- Individual or group. (58 Responses)**
- Name (35 Responses)**
- Organization (35 Responses)**
- Group Name (23 Responses)**
- Lead Contact (23 Responses)**
- Question 1 (49 Responses)**
- Question 1 Comments (58 Responses)**
- Question 2 (47 Responses)**
- Question 2 Comments (58 Responses)**
- Question 3 (40 Responses)**
- Question 3 Comments (58 Responses)**
- Question 4 (52 Responses)**
- Question 4 Comments (58 Responses)**

William R. Harris
No
COMMENTS OF THE FOUNDATION FOR RESILIENT SOCIETIES (Comment 1 of 2 submitted 10-10-2014) TO THE STANDARD DRAFTING TEAM NERC PROJECT 2013-03 – STANDARD TPL-007-1 TRANSMISSION SYSTEM PLANNED PERFORMANCE FOR GEOMAGNETIC DISTURBANCE EVENTS October 10, 2014 Answer to Question 1: No, we do not agree with these specific revisions to TPL-007-1. Detailed responses are below. Requirement R3 should contain steady state voltage “limits” instead of the subjective term “performance.” Measure M3 should contain steady state voltage “limits” instead of the subjective term “performance.” Table 1, “Steady State Planning Events” has been changed to allow “Load loss as a result of manual or automatic Load shedding (e.g. UVLS) and/or curtailment of Firm Tr

Figure 1 - NERC Proposed Profile of Geomagnetic Disturbance Intensity versus Geomagnetic Latitude

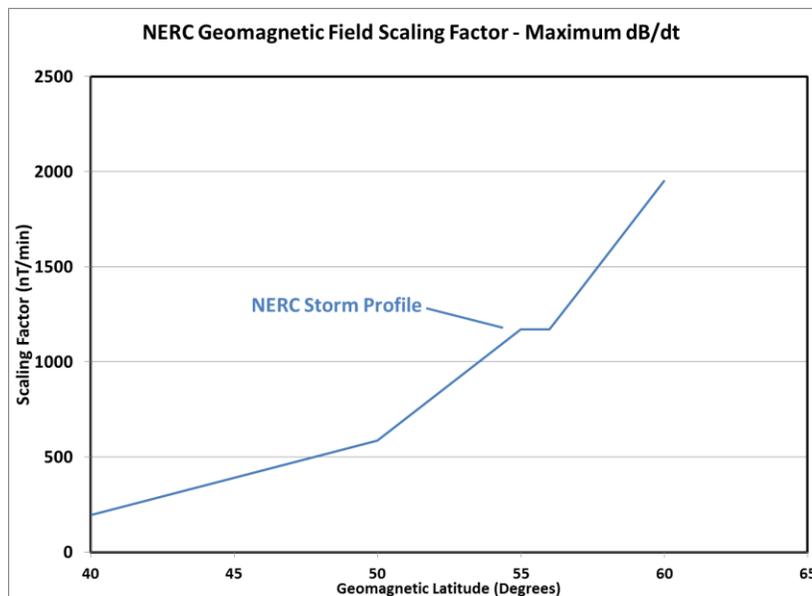
Figure 1 provides a graphic illustration of the NERC Standard proposed geomagnetic field intensity in nT/min, adapted from Table II-1 of α "Alpha" scaling of the geomagnetic field versus latitude across North America².

NERC has developed the intensity and profile described in Figure 1 from statistical studies carried out using recent data from the Image Magnetic observatories located in Finland and other Baltic locations³. This data base is a very small subset of observations of geomagnetic storm events, it is limited in time and does not include the largest storms of the modern digital data era and is limited in geography as it only focuses on a very small geographic territory at very high latitudes. The lowest latitude observatory in the Image array is at a geomagnetic latitude approximately equivalent to the US-Canada border, so this data set would not be able to explore the profile at geomagnetic latitudes below 55° and therefore reliably characterize the profile across the bulk of the US power grid. The NERC Reference Field excludes the possibility of a Peak disturbance intensity of greater than 1950 nT/min and further excludes that the peak could occur at geomagnetic latitudes lower than 60°. As observation data and other scientific analysis will show, both of these NERC exclusions are in error.

Figure 2 – NERC 100 Year Storm Reference Profile and Observations of dB/dt in 1972, 1982 and 1989 Storms that exceed the NERC Reference Profile

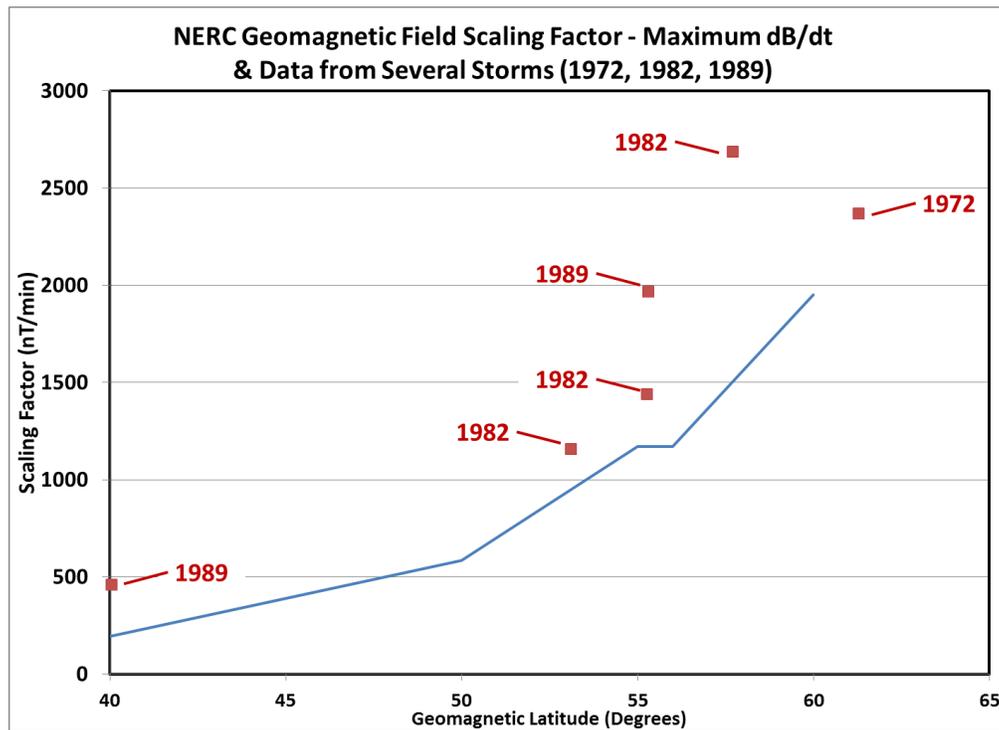
For the NERC Reference profile of Figure 1 to be considered a conservative or 1 in 100 year reference profile, then no recent observational data from storms should ever exceed the profile line boundaries. However as previously noted, the statistical data used by NERC excluded world observations from the large and important March 1989 storm and also from two other important storms that took place in July 1982 and August 1972, a time period that only covers the last ~40 years. In addition, data developed from analysis of older and larger storms such as the May 1921 storm have been excluded by NERC in the development of this reference profile. In just examining the additional three storms of August 4, 1972, July 13-14, 1982, and March 13-14, 1989, a number of observations of intense dB/dt can be cited which exceed the NERC profile thresholds. Figure 2 provides a summary of these observed dB/dt intensities and geomagnetic latitude locations that exceed the NERC reference profile.

As Figure 2 illustrates that are a number of observations that greatly exceed the NERC reference profile at all geomagnetic latitudes in just these three storms alone. The geomagnetic storm process in part is driven by ionospheric electrojet current enhancements which expand to lower latitudes for more severe storms. The NERC Reference profile precludes that reality by confining the most extreme portion of the storm environment to a 60° latitude with sharp falloffs further south. This NERC profile will not agree with the reality of the most extreme storm events. The excursions above the NERC profile boundary as displayed in Figure 2 clearly points out these contradictions.

Figure 3 – Comparison of NERC Peak at 55° Latitude versus Actual Observed dB/dt

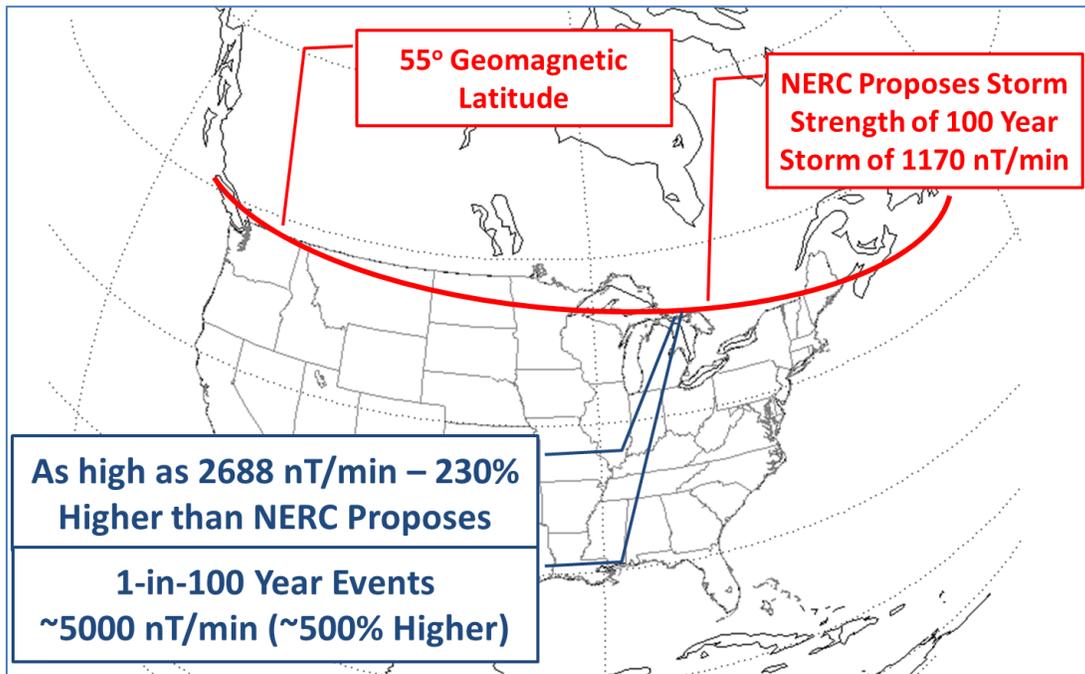
In terms of what this implies for the North American region, a series of figures have been developed to illustrate the NERC reference field levels at various latitudes and actual observations that exceed the NERC reference thresholds. Figure 3 provides a plot showing via a red line the ~55° geomagnetic latitude across North America which extends approximately across the US/Canada border. Along this boundary, the NERC Reference profile sets the Peak disturbance threshold at 1170 nT/min, but when

considering the three storms not included in the NERC statistics database, it is clear that peaks of ~2700 nT/min have been observed at these high latitudes over just the past ~40 years. As will be discussed later, it is also understood that extremes up to ~5000 nT/min can occur down to these latitudes. Figure 4 provides a similar map showing the boundary at 53° geomagnetic latitude across the US and per the NERC Reference profile, the peak threat level would be limited to 936 nT/min. Yet at this same latitude at the Camp Douglas Station geomagnetic observatory, a peak dB/dt of ~1200 nT/min was observed during the July 1982 storm. Figure 5 provides a map showing the boundary at 40° geomagnetic latitudes and the NERC Reference peak at this location of only 195 nT/min. This figure also notes that in the March 1989 storm the Bay St. Louis observatory observed a peak dB/dt of 460 nT/min, this is 235% larger than the NERC peak threshold.

Figure 4 - Comparison of NERC Peak at 53° Latitude versus Actual Observed dB/dt

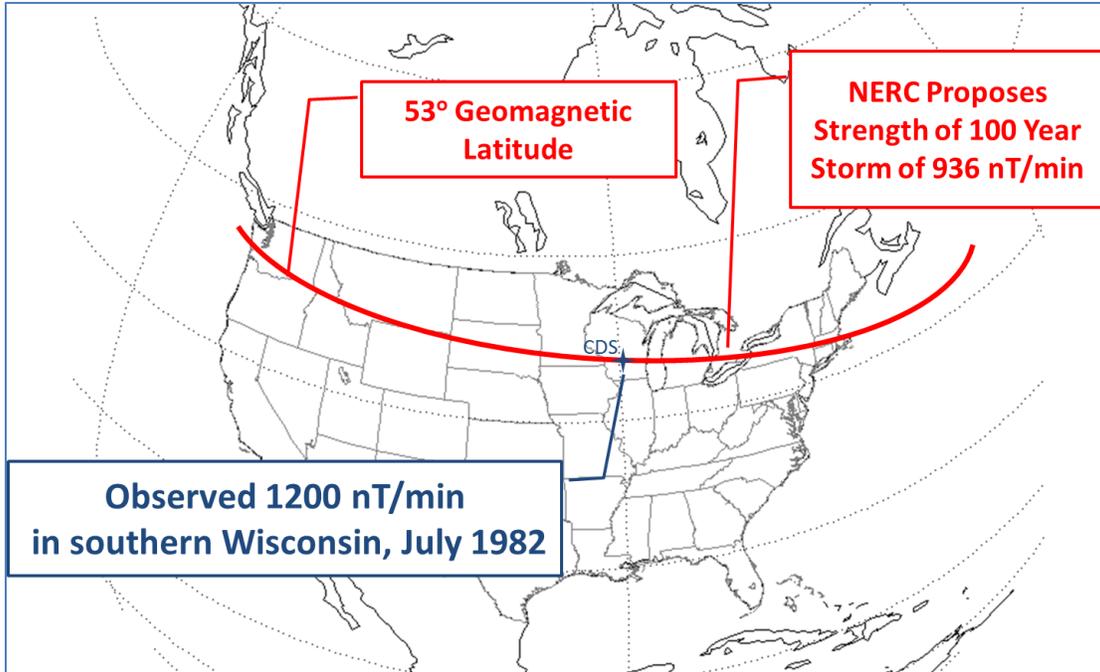
In summary, these storm observations limited to just three specific storms which happen to fall outside the NERC statistical database all show observations which exceed the NERC Reference profile at all latitudes. This illustrates that the NERC Reference profile cannot be a 1 in 100 year storm reference waveform and is not conservative. It should also be noted that even these three storm events are not representative of the worst case scenarios. In an analysis limited to European geomagnetic observatories, a science team publication concludes “there is a marked maximum in estimated extreme

Figure 6 – Scientific Estimates of Extreme Geomagnetic Storm Thresholds compared to Propose3d NERC Draft Standard Profile

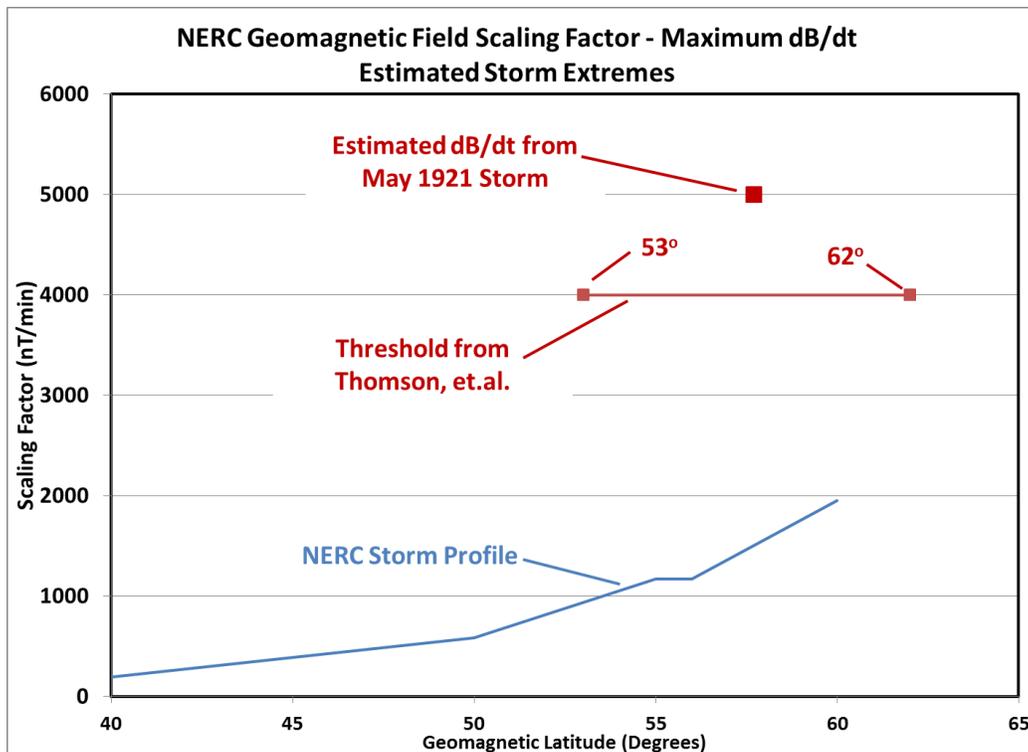
levels between about 53 and 62 degrees north” and that “horizontal field changes may reach 1000-4000 nT/minute, in one magnetic storm once every 100 years”⁴. One advantage of this European analysis, it did not exclude data from older storms like the March 1989 and July 1982 storms, unlike in the case of the NERC database statistical analysis. In another publication the data from the May 1921 storm is assessed with the following findings; “In extreme scenarios available data suggests that disturbance levels as high as ~5000 nT/min may have occurred during the great geomagnetic storm of May 1921”⁵. In another recent publication, the authors conclude the following in regards to the lower latitude expansion of peak disturbance intensity; “It has been established that the latitude threshold boundary is located at about 50–55 of MLAT”⁶. It should be noted that one of the co-authors of this paper is also a member of the NERC Standards drafting team. All of these assessments are in general agreement and all call into question the NERC Reference Profile. Figure 6 provides a comparison plot of these published results with respect to the NERC Draft Standard profile and illustrates the significant degree of inadequacy the NERC Reference profile provides compared to these estimates of 100 Year storm extremes.

Figure 8 – Red Circles provide Region of Ground Model Validation using GIC observations from Kappenman/Radasky White Paper.

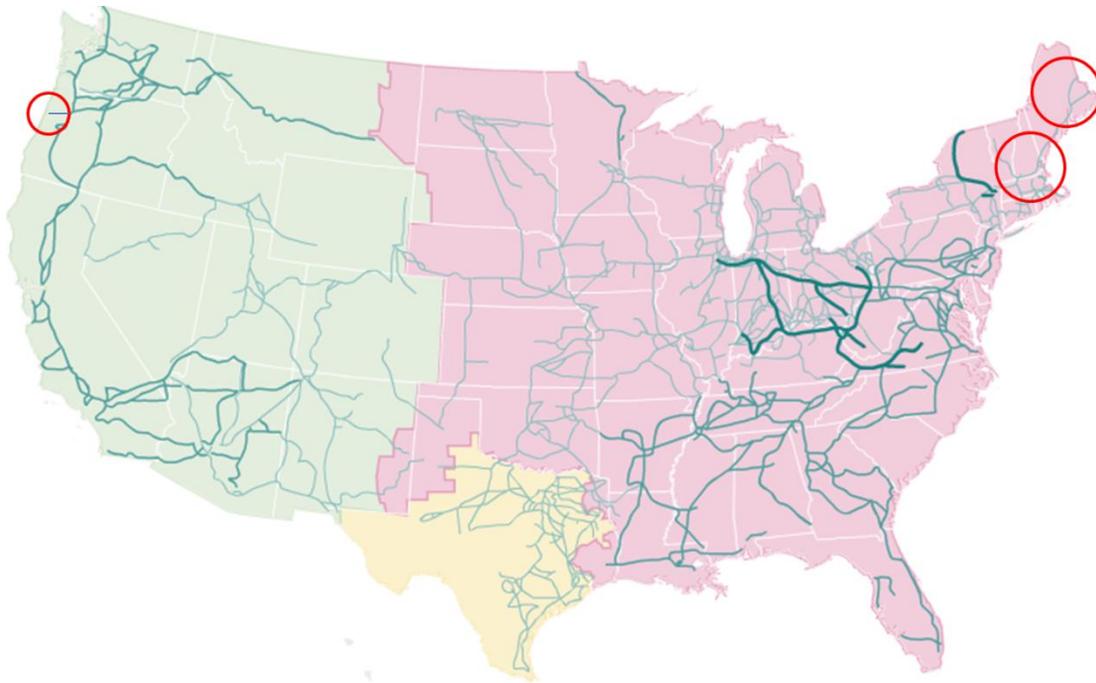
also known with high precision and many commercially available simulation tools can readily compute the GIC for a uniform 1 V/km geo-electric field. This calculation provides an intrinsic GIC flow benchmark that can be used to convert any observed GIC to an regionally valid Geo-Electric Field that produced that GIC. Further this calculation is derived over meso-scale distances on the actual power grid assets of concern. As summarized in a recent IEEE Panel discussion, this approach allows for wide area estimates of ground response than possible from conventional magneto-telluric measurements¹⁰. Figure 8 provides a map showing the locations of the Chester, Seabrook and Tillamook GIC observations and the approximate boundaries based upon circuit parameters of the ground region that were validated.

Figure 9 – GIC Observatories and US Grid-wide validation regions.

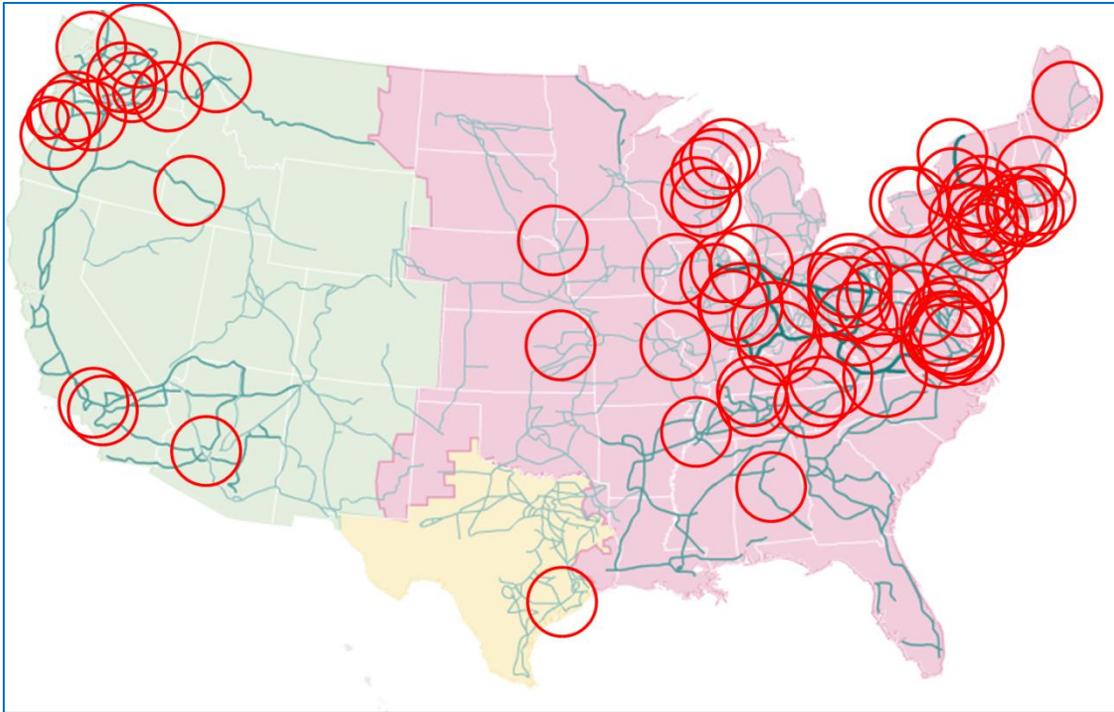
As filed in a recent FERC Docket filing¹¹, ~100 GIC monitoring sites have operated and are collecting data across the US. Using these analysis techniques and the full complement of GIC monitoring locations, it is possible to accurately benchmark major portions of the US as shown in the map in Figure 9. As shown in this figure, the bulk of the Eastern grid is covered and in many locations with overlapping benchmark regions, such that multiple independent observations can be used to confirm the accuracy of the regional validations. The same is also true for much of the Pacific NW. As noted in Meta-R-319 and shown below is Figure 10 from that report, these two regions are the most at-risk regions of the US Grid.

Figure 10 – Map of At-Risk Regions from Meta-R-319 Report for 50° Severe Storm Scenario

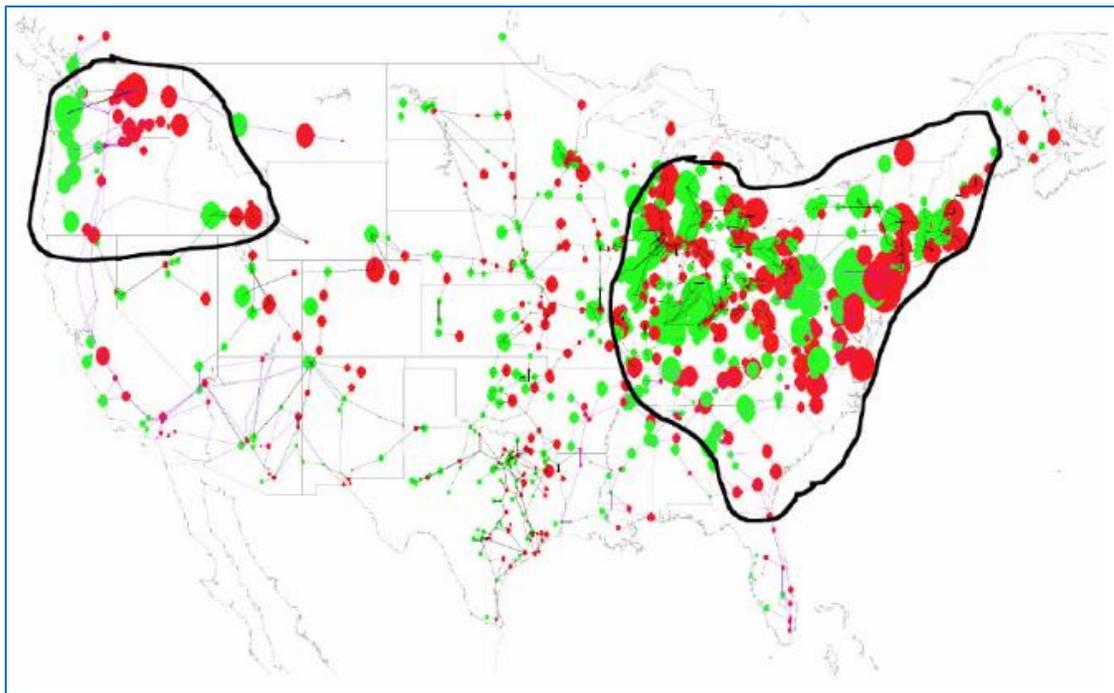
Each of these GIC measurements can define and validate the geo-electric field parameters over considerable distance. In the example of the Chester Maine case study, the validations in the case of the 345kV system can extend ~ 250km radius. At higher kV ratings, the footprint of GIC and associated geo-electric field measurements integrates over an even larger area. As these measurements are accumulated over the US, the characterizations provide a very complete coverage with many

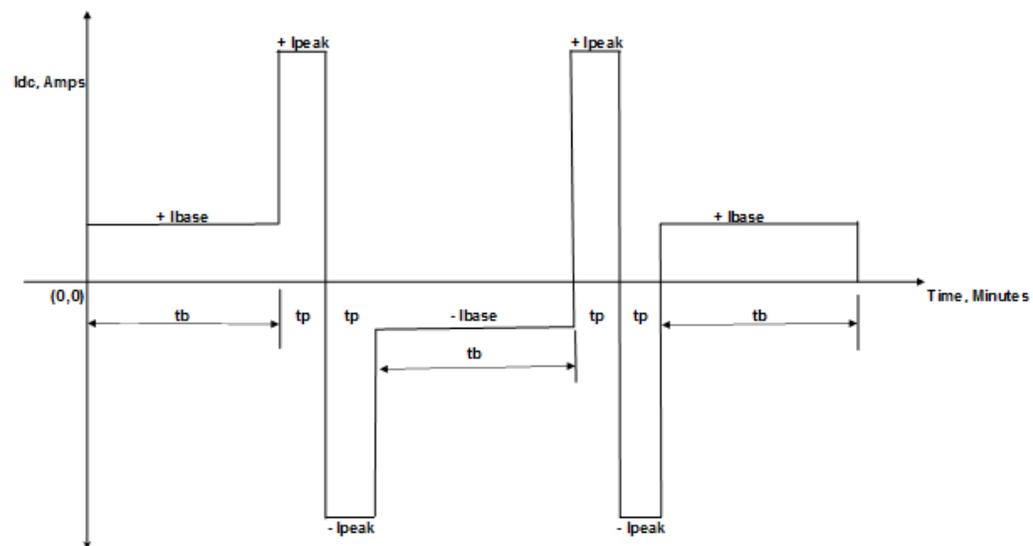
Users would not be able to predict, to any degree of accuracy, what GIC signature a transformer would be subjected to during future GMD storms. This is since the actual GIC signature will depend on the specific parameters and location of the future GMD storms. Unless a user requires thermal assessment of their fleet of transformers to actual GIC signatures, the user should be able to use a Standard GIC Signature; where the parameters of the signature (magnitudes and durations of the different parts of the signature) would be specified by the user.

This is parallel to the standard signatures used by the transformer / utility industry Standards (IEEE & IEC) for lightning surges, switching surges, etc.; where standard signatures (wave – shapes) are used for evaluating the dielectric capability of transformers.

We recommend that the NERC document suggest using the Standard GIC signature, proposed in the upcoming IEEE Std. PC57.163 GIC Guide, shown below. This signature was based on observation / study of a number of signatures of measured GIC currents on a number of power transformers located in different areas of the country. It was recognized that GIC current signatures can be generally characterized by a large number of consecutive narrow pulses of low – to – medium levels over a period of hours interrupted by high peaks of less than a minute, to several minutes, duration. Therefore, GIC signatures are made of two main stages of GIC; namely:

Figure 1: Snapshot of Geoelectric Fields of 1989 Quebec GMD event (Source: Storm Analysis Consultants).

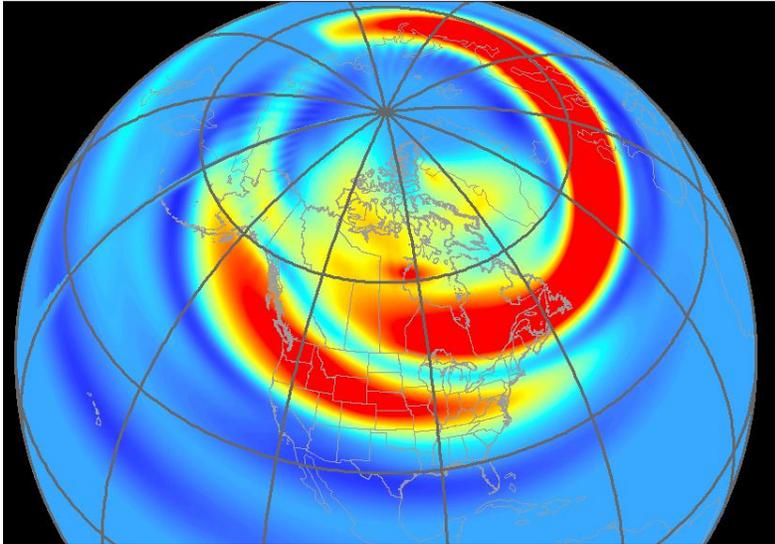
The 1989 Quebec Storm is very well-studied event, and is a dramatic example of the impacts of GMD on power grids. The loss of power in the Province of Quebec, failure of the Salem transformer, and other grid anomalies associated with the storm are all well documented. The GMDTF was formed, and FERC Order 779 issued, to ensure grid resilience for events that will be much larger than the 1989 Quebec Storm, such as the 1921 Railroad Storm. The two figures below show a side-by-side comparison of the 1989 and 1921 storms. The geographic size, and also the latitude locations are quite striking.

The use of the 1989 Quebec Storm as the benchmark event is of concern because simply scaling the field strengths of the 1989 Storm higher (an “intensification factor” of 2.5 is used), but leaving the same geographic footprint, does not appear to be a valid approach. While the 2.5 scaling factor is described to produce local “hot spots” of 20 V/km, in agreement with earlier findings, it fails to consider the well-known GMD phenomena that the electrojets of larger storms shift southward, as can be seen in comparing the two figures. By using the geographic footprint of the 1989 storm, the new benchmark will predict geoelectric field levels that are incorrect for geomagnetic latitudes below 60 degrees, where the center of the new benchmark storm has been set.
